JONES & BEACH ENGINEERS INC.

January 18, 2022

RE: Response Letter
19 Old Gonic Road, Rochester, NH
Tax Map 131, Lot 1
JBE Project No. 21090

DRAWING No.
PH
SHEET 46 OF 46
JBE PROJECT NO. 21090

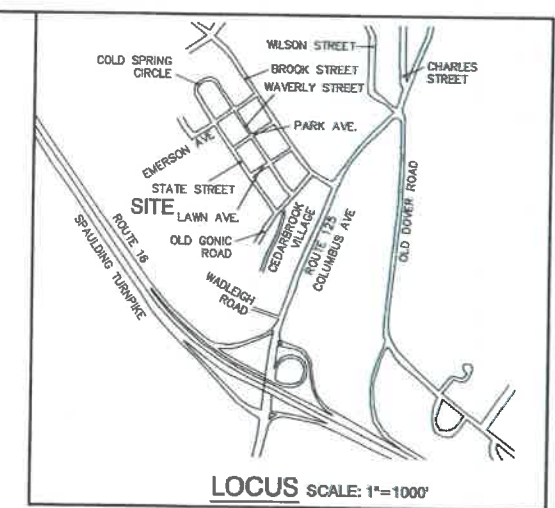
8. *The phasing plans for the project will be important. Please include temporary stormwater management and indicate how water will flow prior to the permanent stormwater system being stabilized."*

3. *Phasing was discussed at TRG. Please provide a proposed phasing plan.*

RESPONSE: Phasing plan has been provided. Temporary sediment ponds will be outlined in the SWPPP and modified as needed during construction. SWPPP inspections will be required as part of this development as well.

RESPONSE: A proposed phasing plan is included with this submission.
